January 29, 2018
PERMIT MODIFICATION APPROVAL
Horizontal 6A / New Drill

Re: Permit Modification Approval for M05H
47-051-01914-00-00

Modified Permit to Extend Lateral into Additional Leases

From: Adkins, Laura L
Sent: Friday, January 19, 2018 10:16 AM
To: 'Laird, Susan'
Cc: Hayes, Jenny
Subject: Longworth Mods

FILE #: LONGWORTH M05H-REV1.1
 DRAWING #: LONGWORTH M05H-REV1.1
 SCALE: 1" = 2000'
 MINIMUM DEGREE OF ACCURACY: 1/2500
 PROVEN SOURCE OF ELEVATION: U.S.G.S. MONUMENT THOMAS 1498.81'

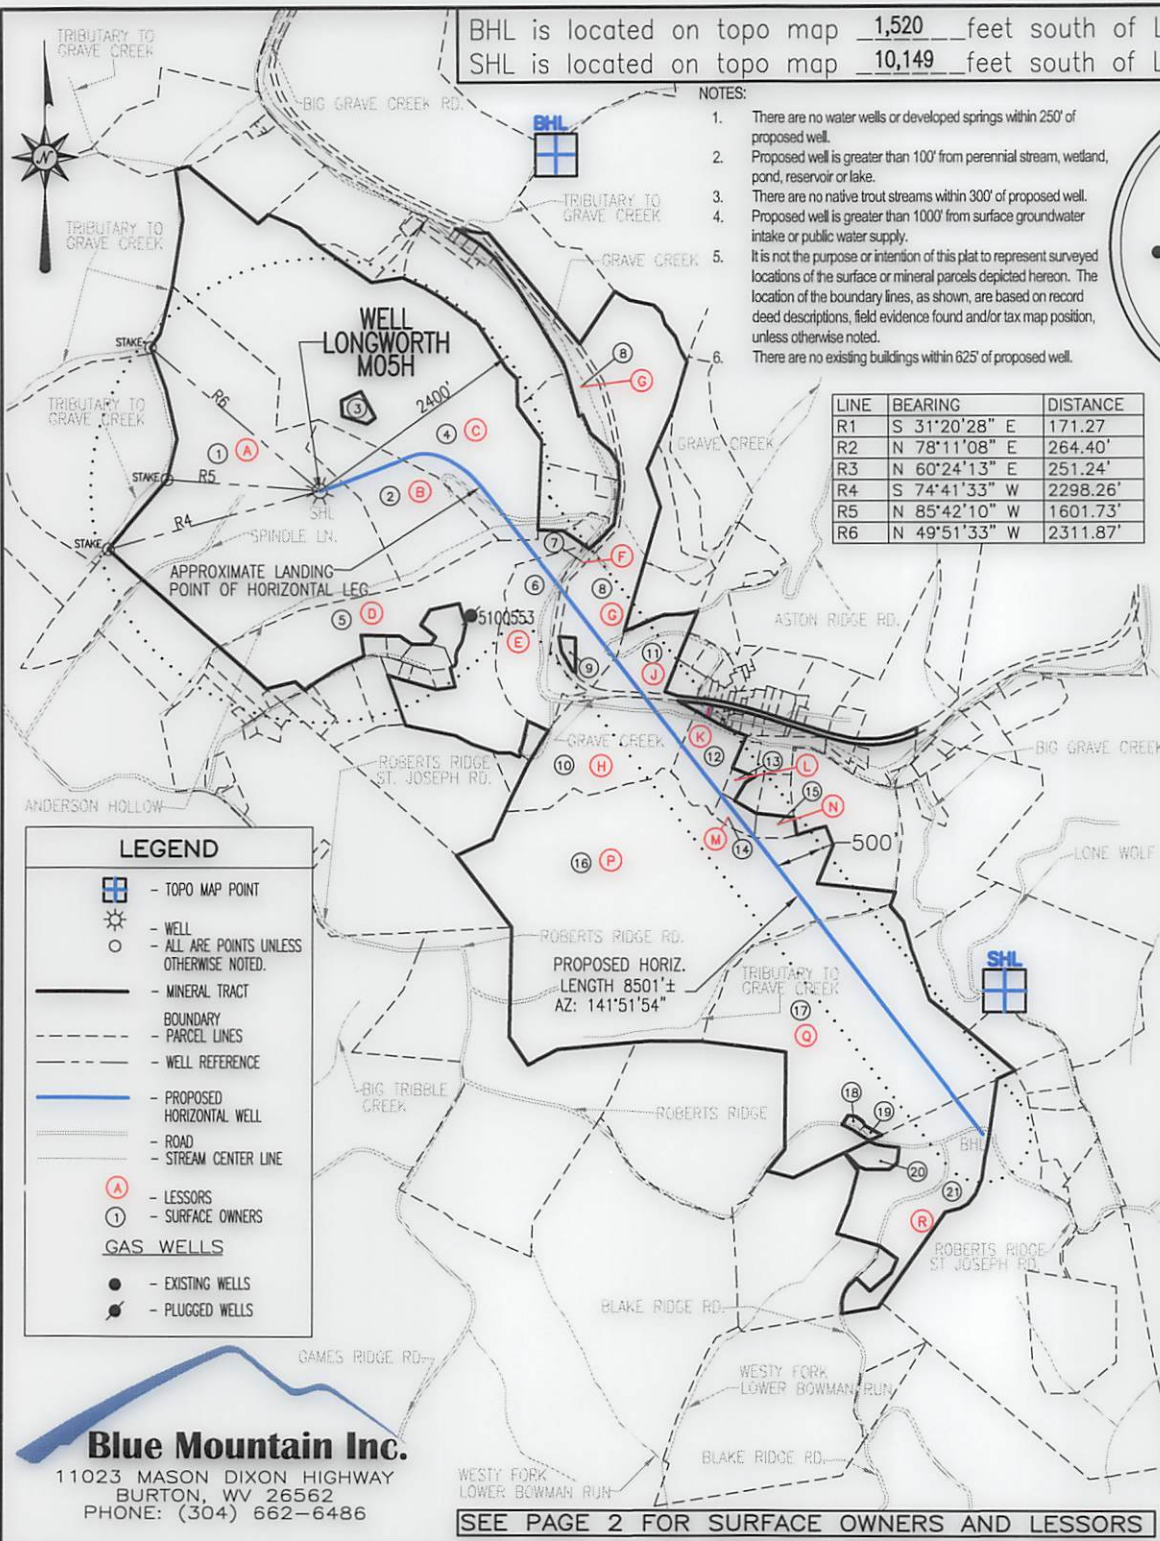
6B Horizontal lengths do not match the horizontal lengths on plats. We request to have the horizontal length from landing point to TD on the 6B as well as the plat.
